**ADDENDUM No. 2**  
**Request for Competitive Sealed Proposals (CSP)**  
**21CSP034 Roofing Repairs at Martin Middle School**

**ADDENDUM NO. 2**

Roofing Repairs at Martin Middle School  
Austin Independent School District  
Solicitation No.: 20CSP106

AUSTIN  
 INDEPENDENT SCHOOL DISTRICT  
 ROOFING REPAIRS AT  
 MARTIN MIDDLE SCHOOL  
 PROJECT NO.: 19-0037-MARTIN  
 SOLICITATION NO.: 21CSP034

ROOF SCOPE/WARRANTY PLANS, SCHEDULES, AND LEGEND  
 DRAWN BY: MWH  
 CHECKED BY: RR  
 DATE: 10/11/2020  
 SHEET: R1 OF 5

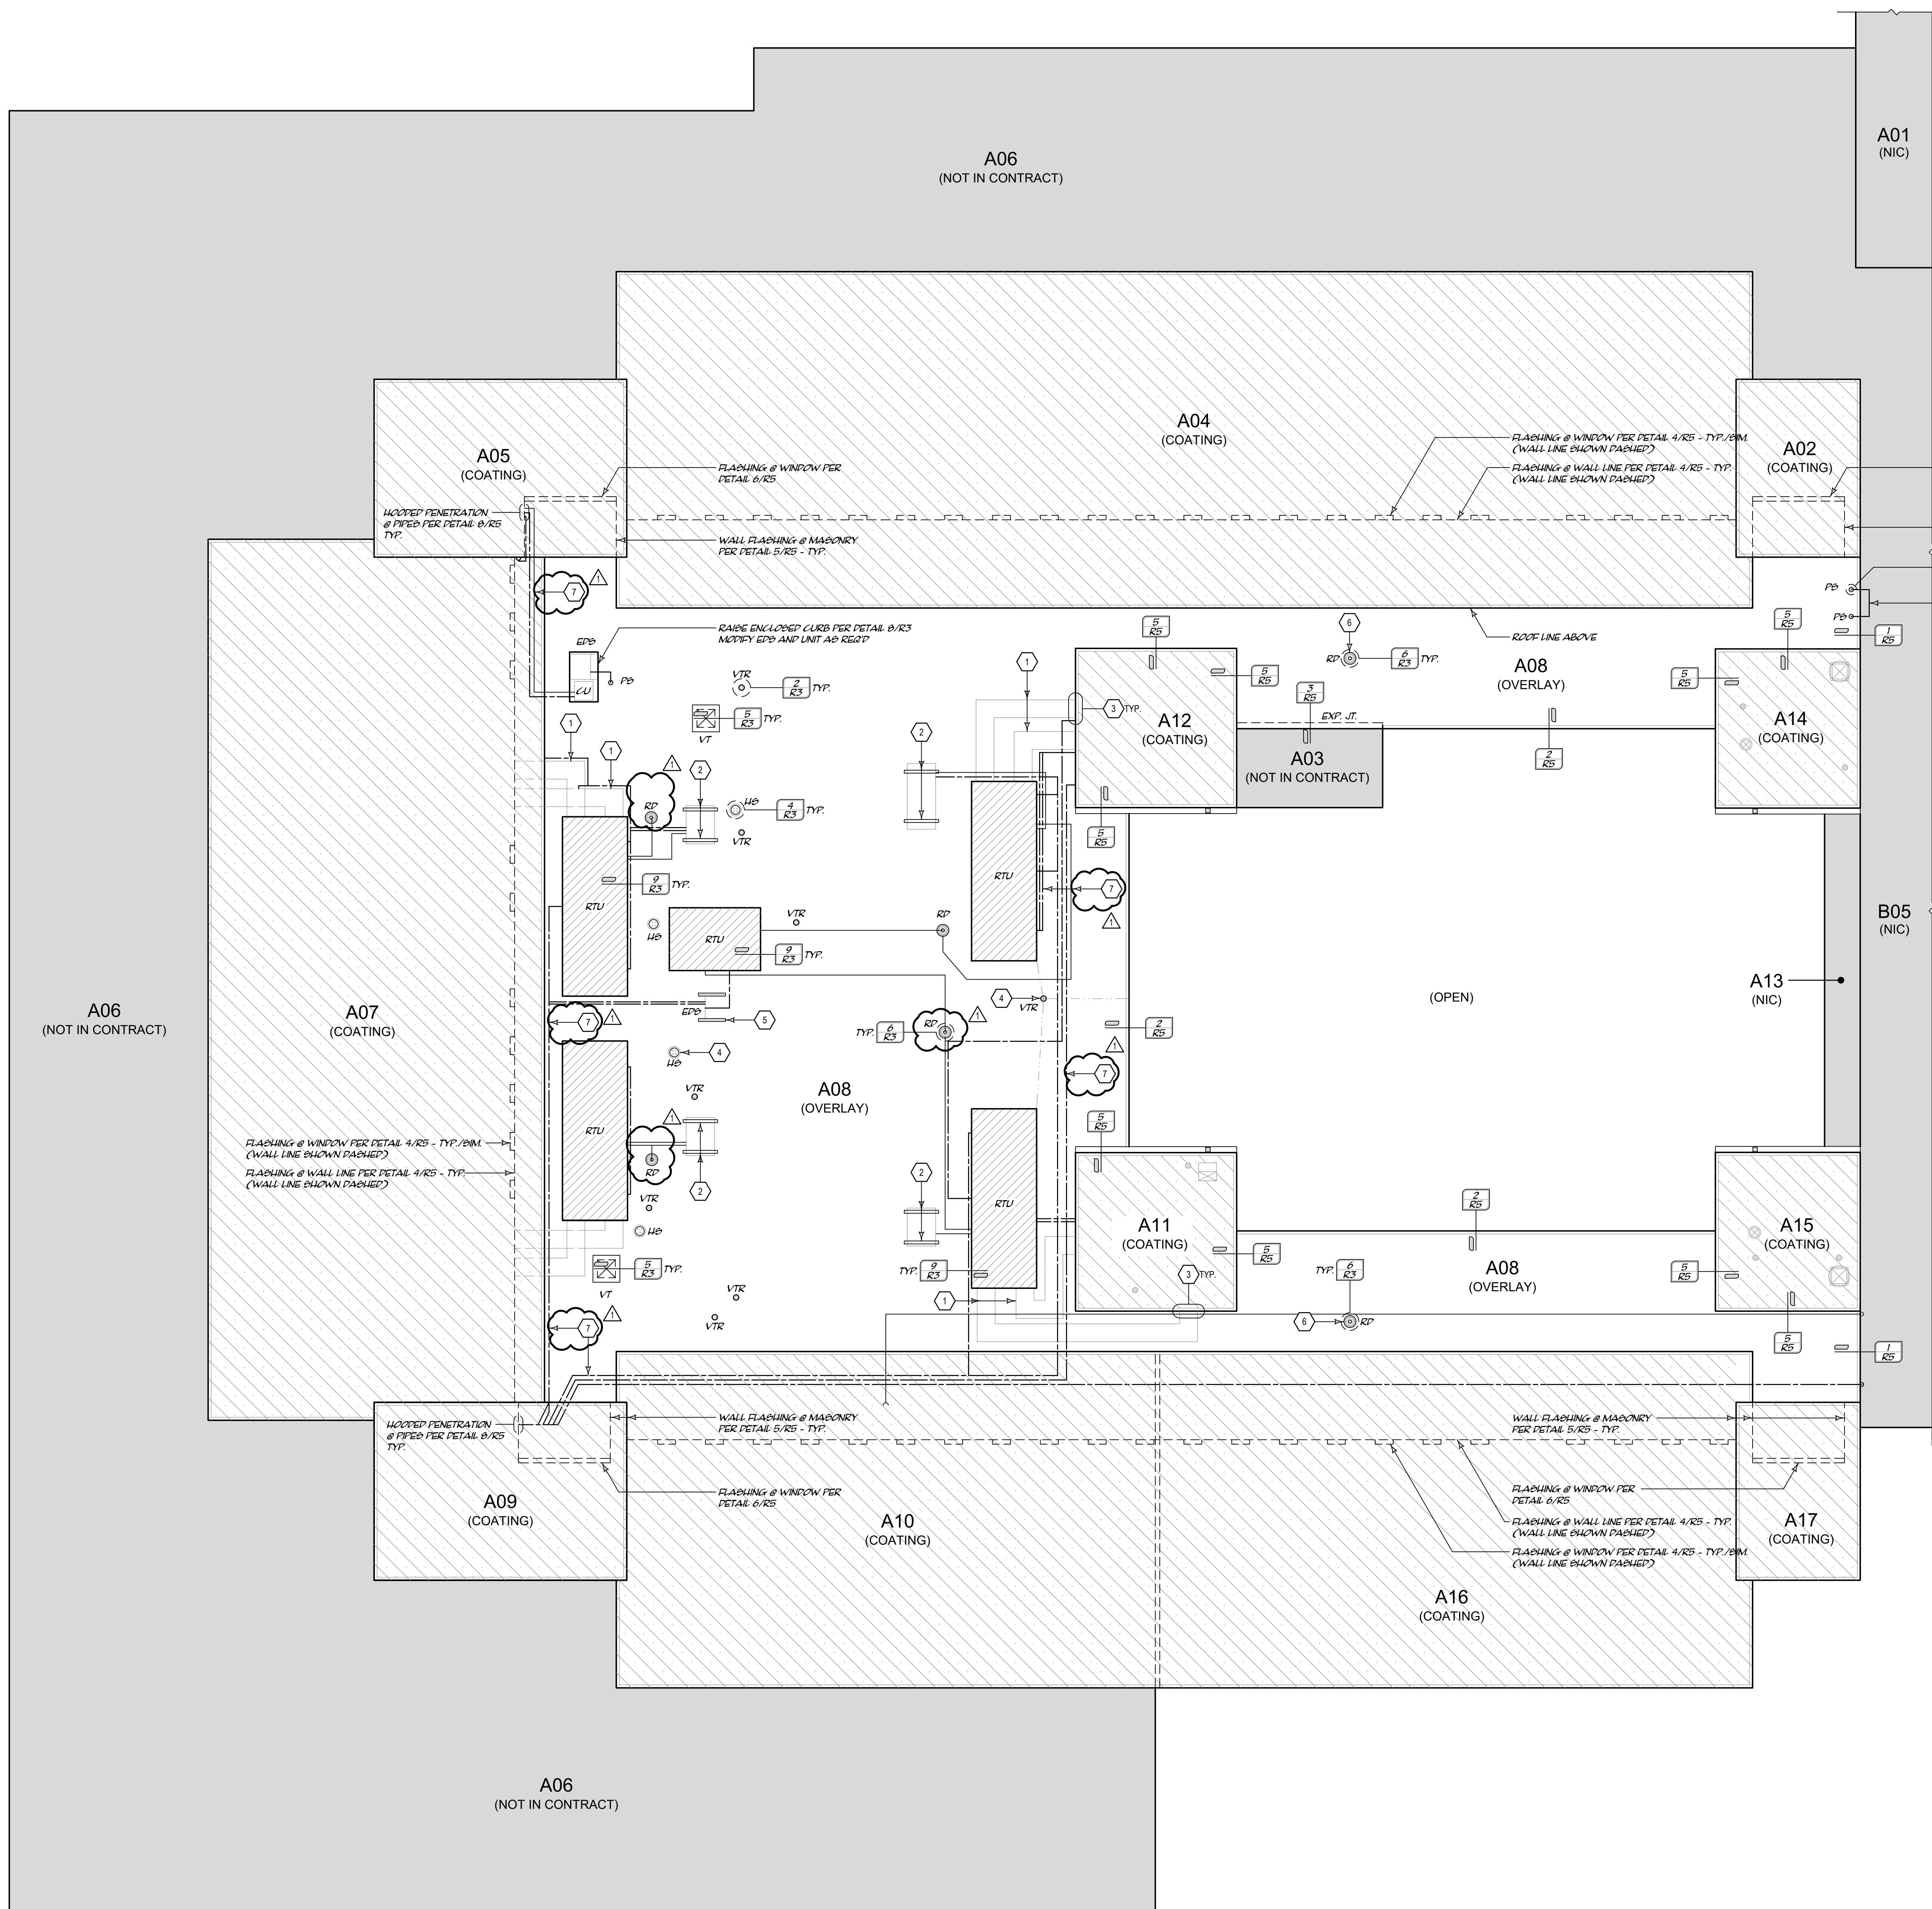
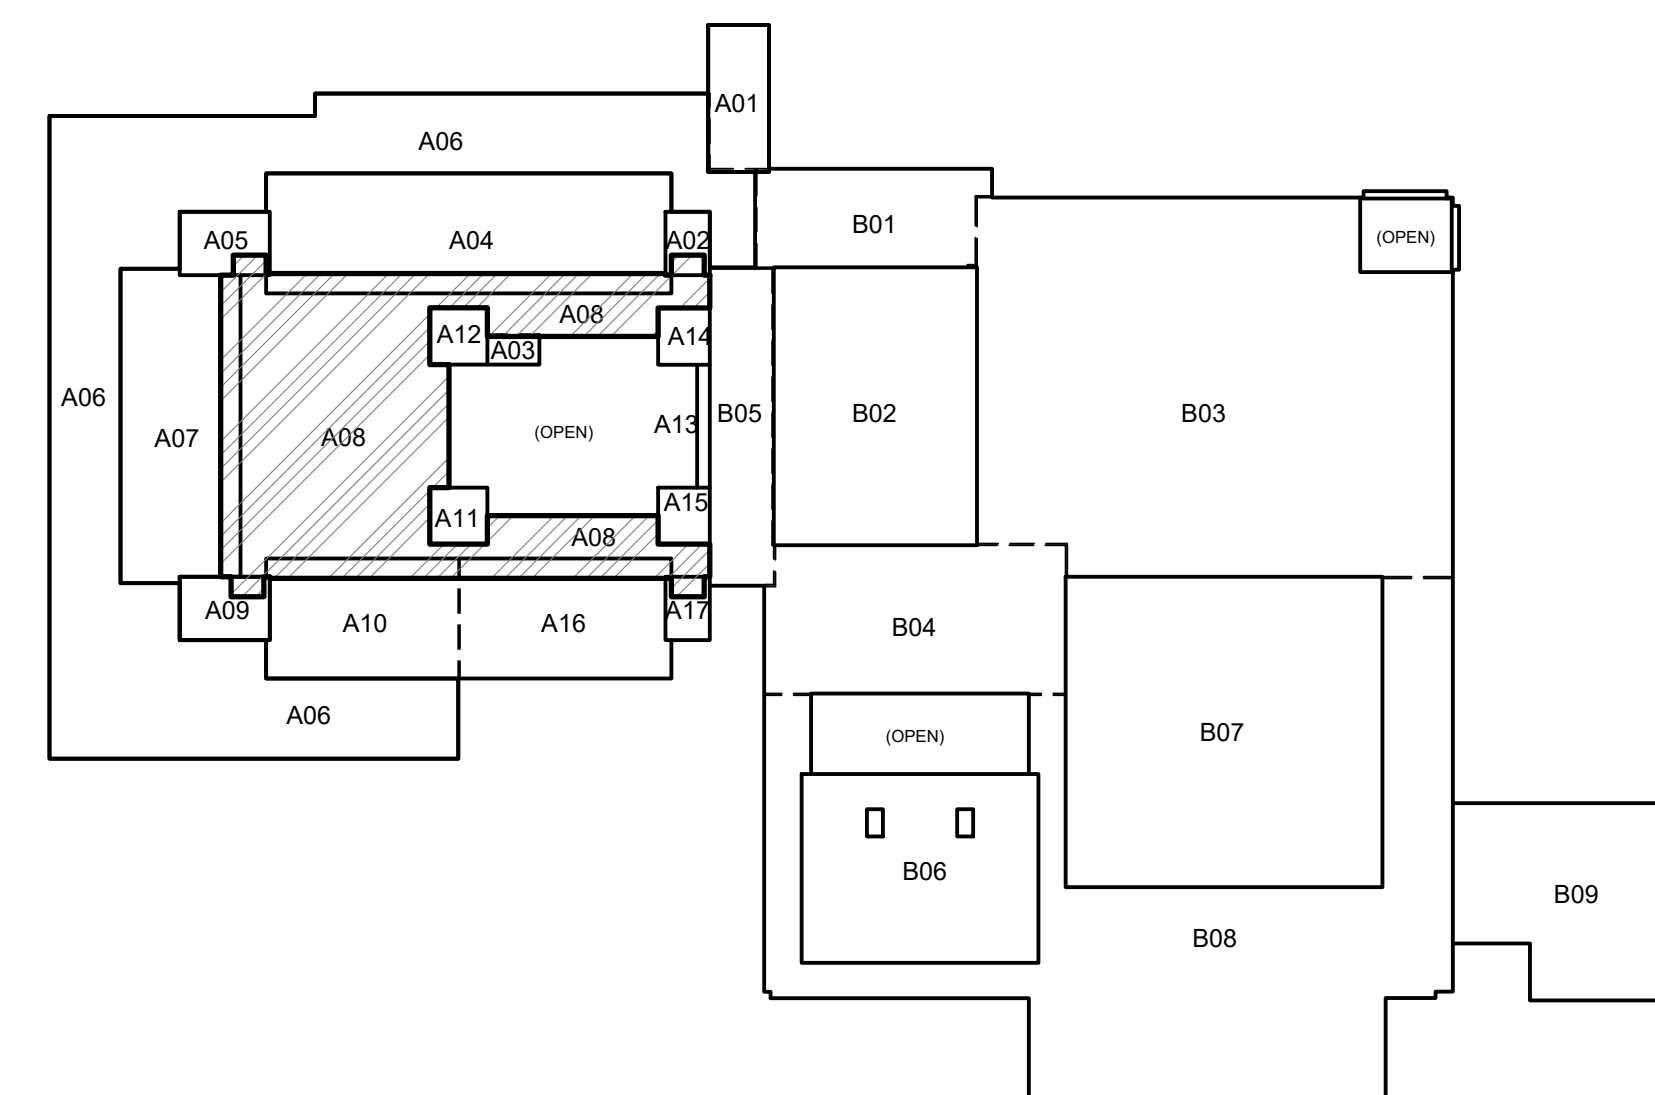
- ITEM 5:** Refer to Drawings: Sheets R0, R1, R2, R3, R4, R5. Delete these sheets in their entirety and replace with the drawing sheets of the same name, attached to this addendum.
